Project Number	T23.101	Project Name	Neath Industrial Estate
Contact/Participants	NPT Highways	Date	26 th September 2023
Noted by	Asbri Transport Limited		
Subject	Planning application 22/1092 Land adjoining Macron Store -proposed cladding of façade & roofs

Technical Note

PLANNING APPLICATION NO: 2/3/22/1092/00
APPLICANT: MR HUW JENKINS
LOCATION: LAND ADJOINING MACRON STORE, NEATH
ABBEY ROAD INDUSTRIAL ESTATE, NEATH,
NEATH PORT TALBOT, SA10 7BR
PROPOSAL: PROPOSED CLADDING OF FACADE AND
ROOFS OF EXISTING STEEL SKELETON FRAME
INDUSTRIAL BUILDING AND RECLADDING OF
EXISTING PART-CLADDED CONCRETE FRAME
INDUSTRIAL BUILDING INCLUDING NEW
ROLLER SHUTTER ACCESS DOORS AND
ALUMINIUM POLYESTER COLOUR COATED
WINDOWS AND DOORS

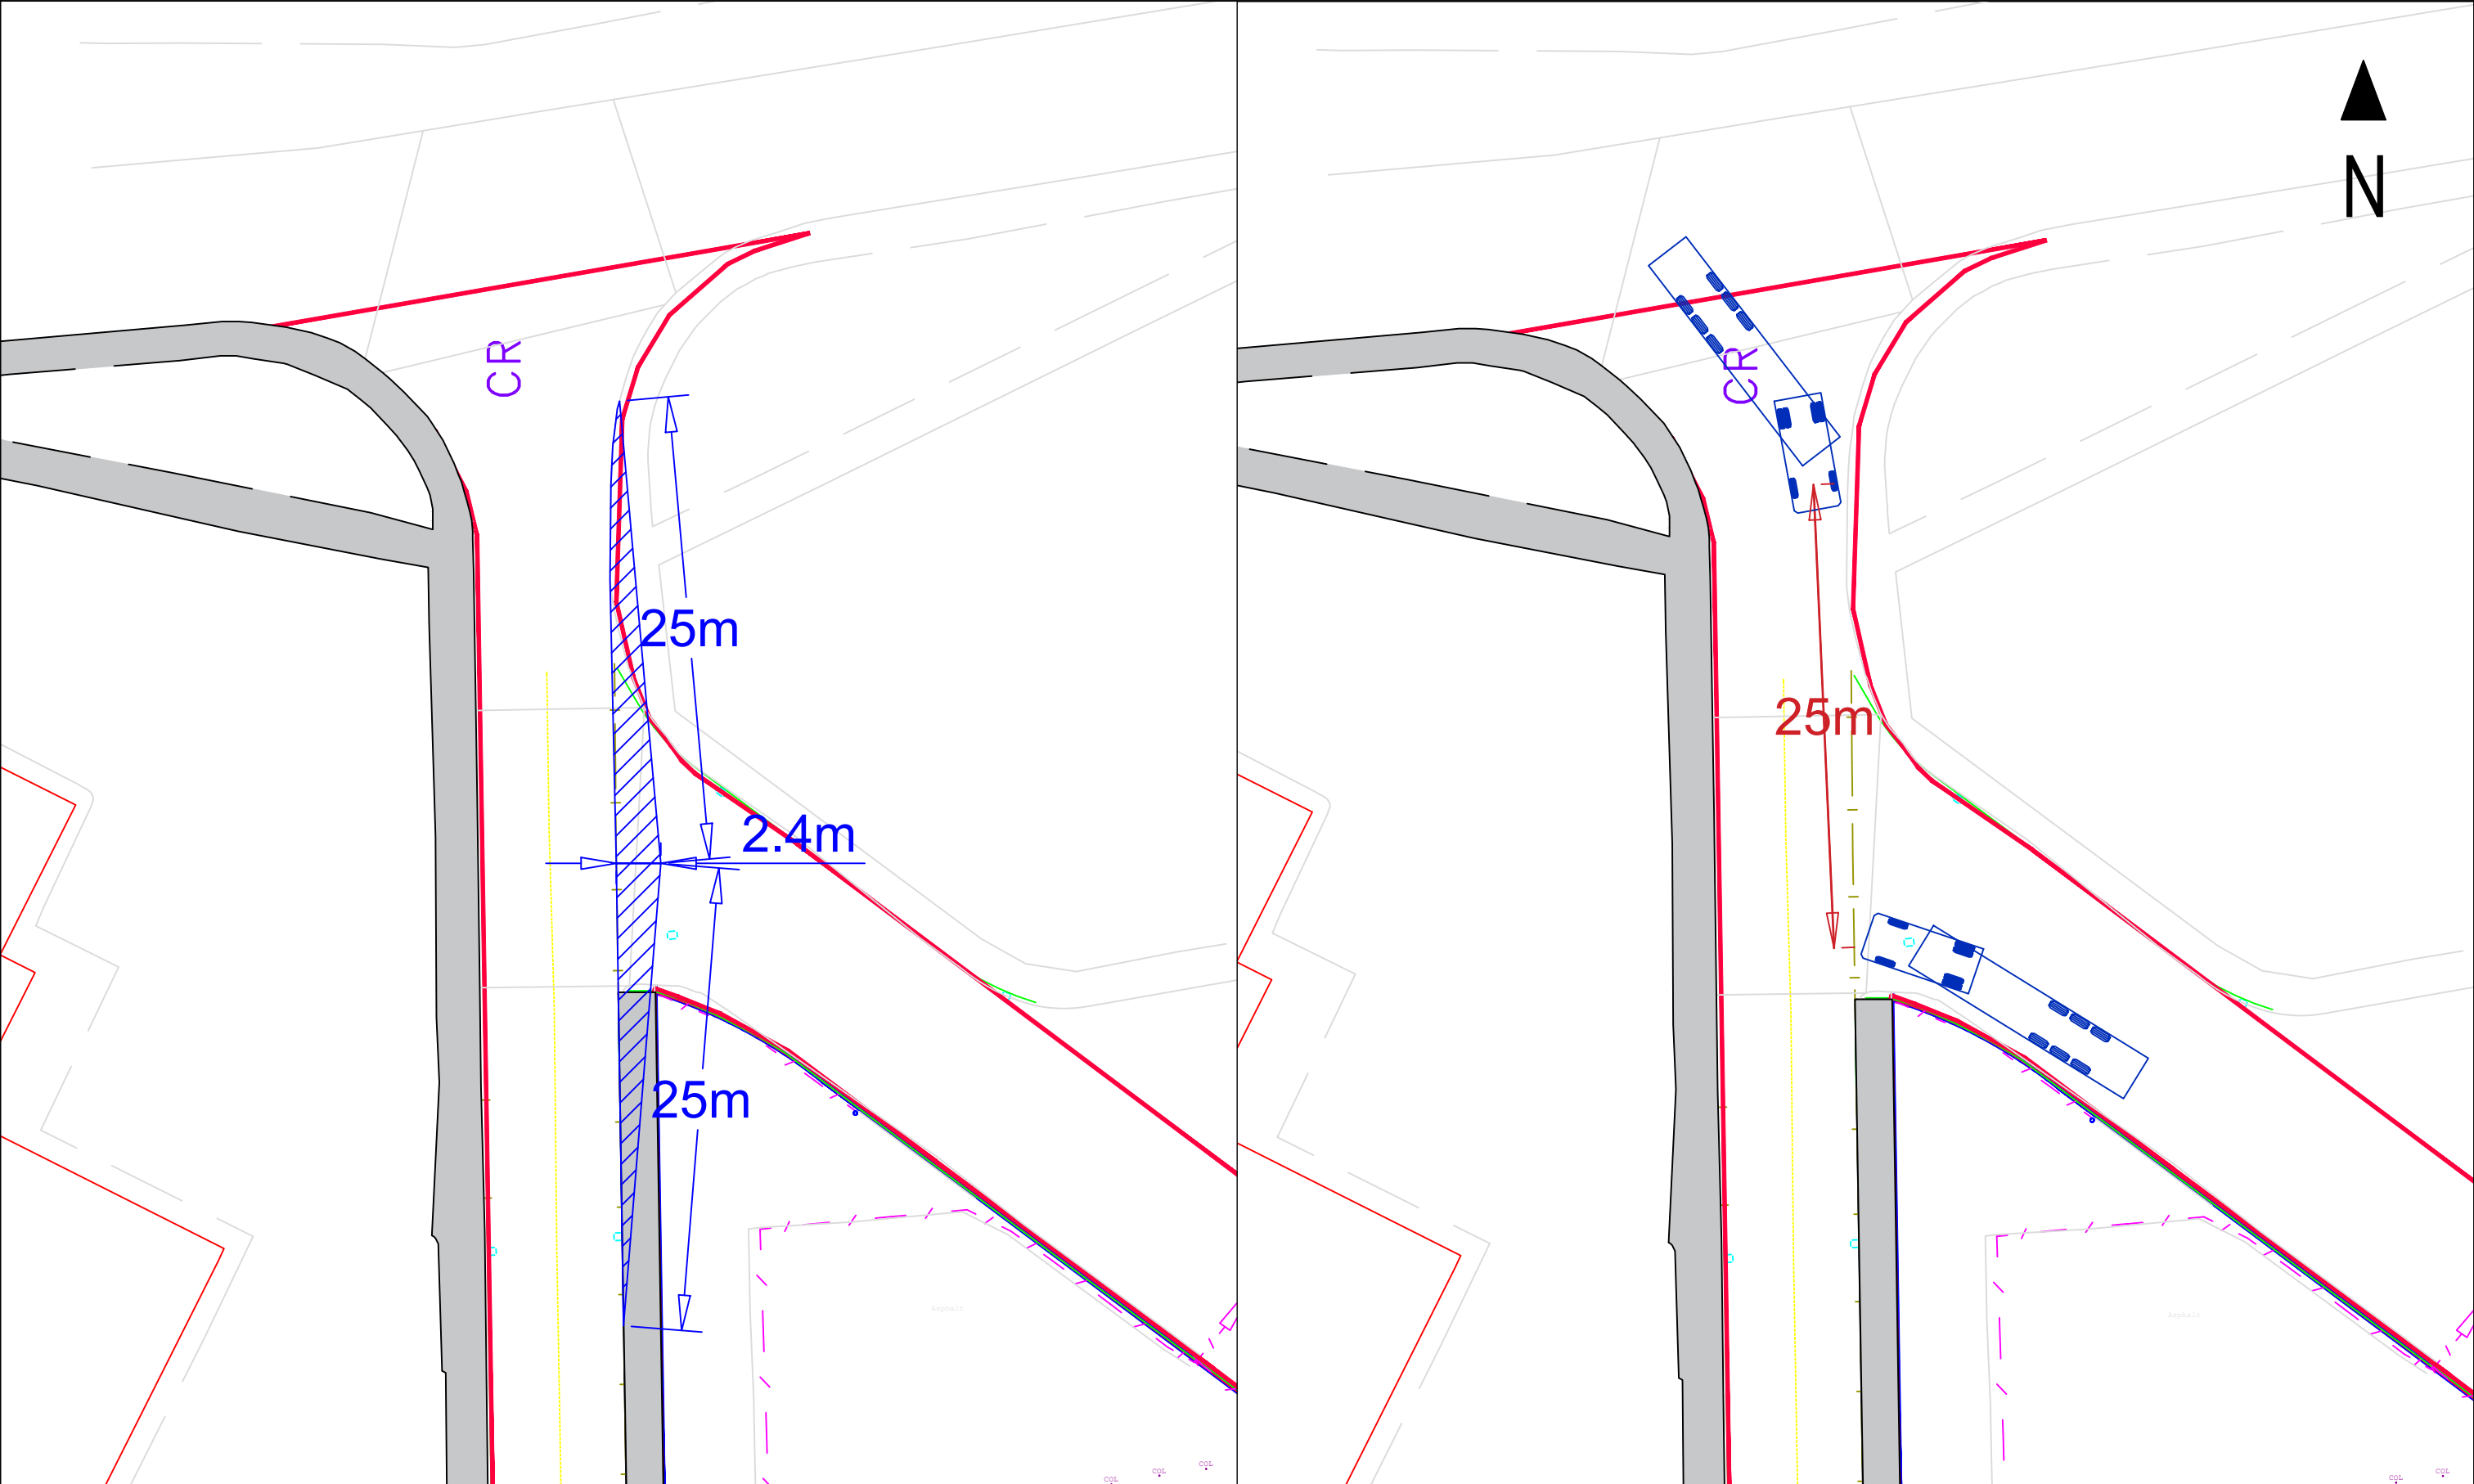
1. Visibility splays to be provided for all junctions, the new exit of the one-way system, and the existing junction that is to be utilised to ensure that the junction is suitable for additional trips.

3. The north-west section of the car park, would require notation that no parking in this area, as spaces 1 & 2 would not have the required 6m reversing distance.

- 3.1.3 **Figure 3.1** details the visibility splays available at the site accesses and internal Industrial Estate junction. Suitable visibility of vehicles entering the industrial estate is available for exiting vehicles.

3.1.7 **Figure 3.1** shows 'Keep Clear' and hatched carriageway markings.

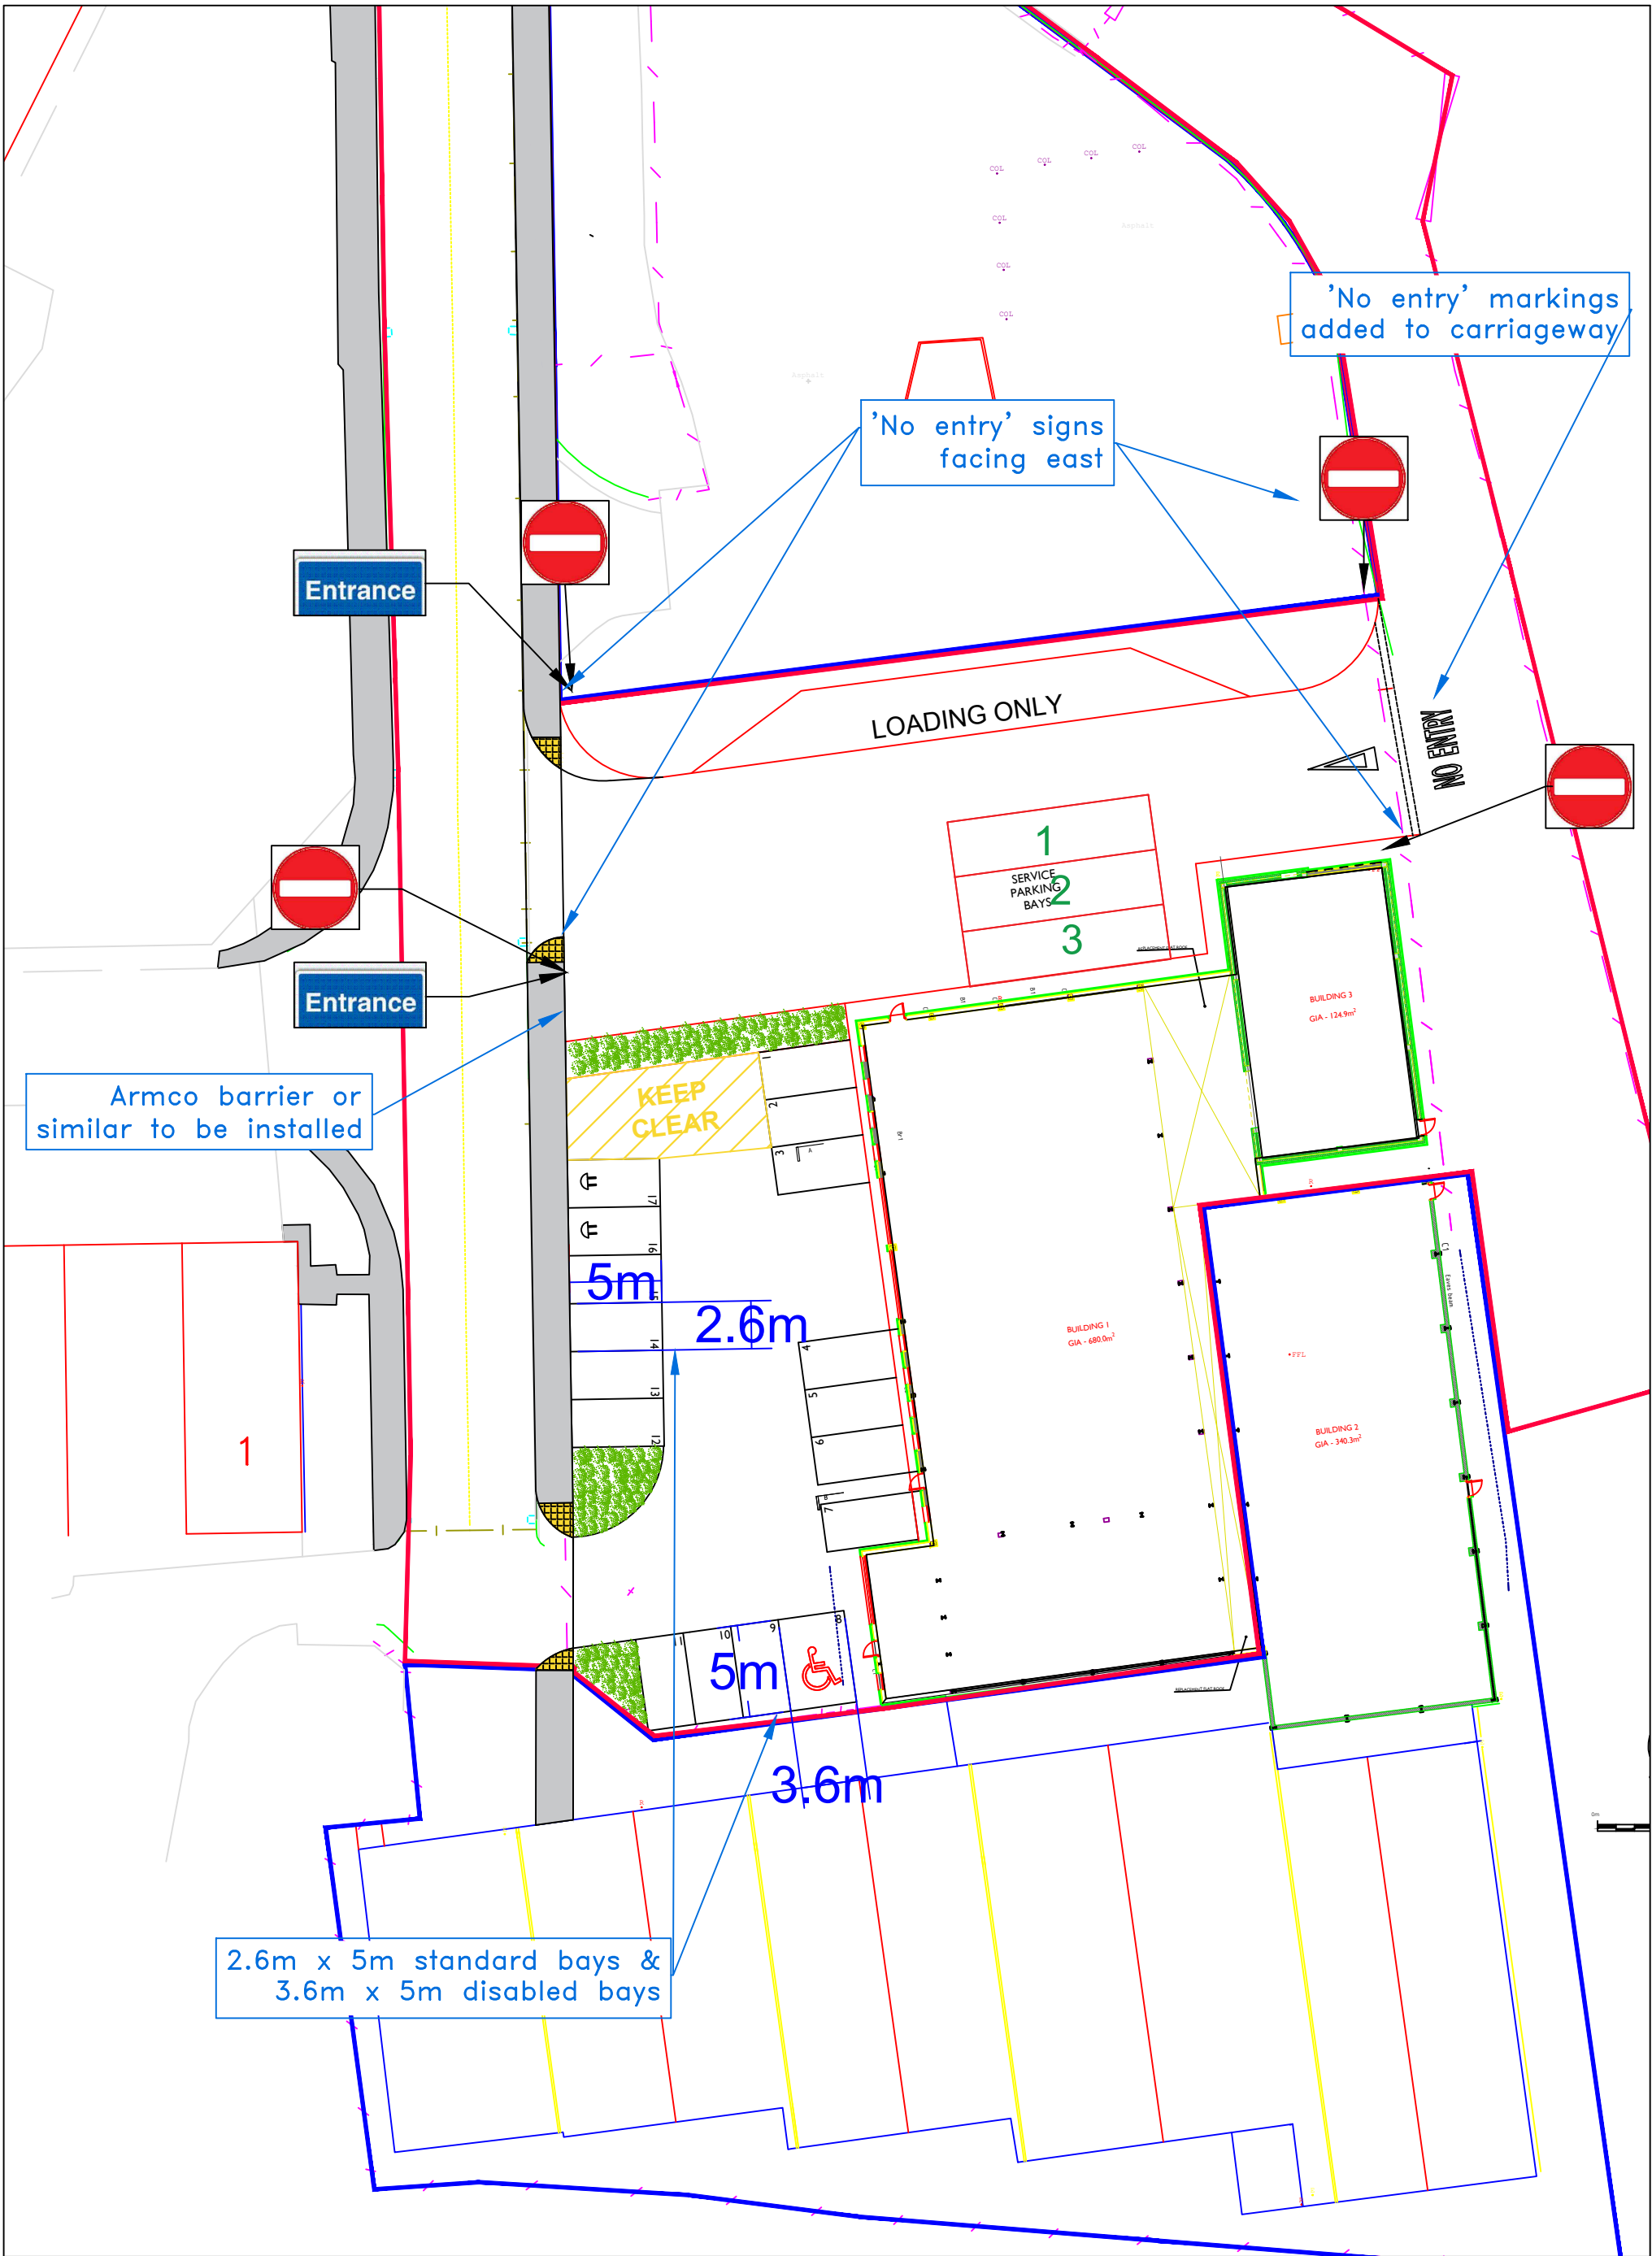
4. Tactile paving would be required to be added on footpath crossings.

6. Service bay 3 is concerning due to the proximity of the footway when reversing to leave the space. A solid barrier such as fencing would need to be in place for pedestrian safety.

7. Signage would be required for the one way entrance, and approved vehicles only to ensure it is not used as a through-way.

3.1.9 **Figure 3.2** details the provision of tactile paving.

3.2.2 **Figure 3.2** notes that an Armco barrier or similar will be installed to protect pedestrians.

3.2.4 Entry and No Entry signs and carriageway markings are shown on **Figure 3.2**
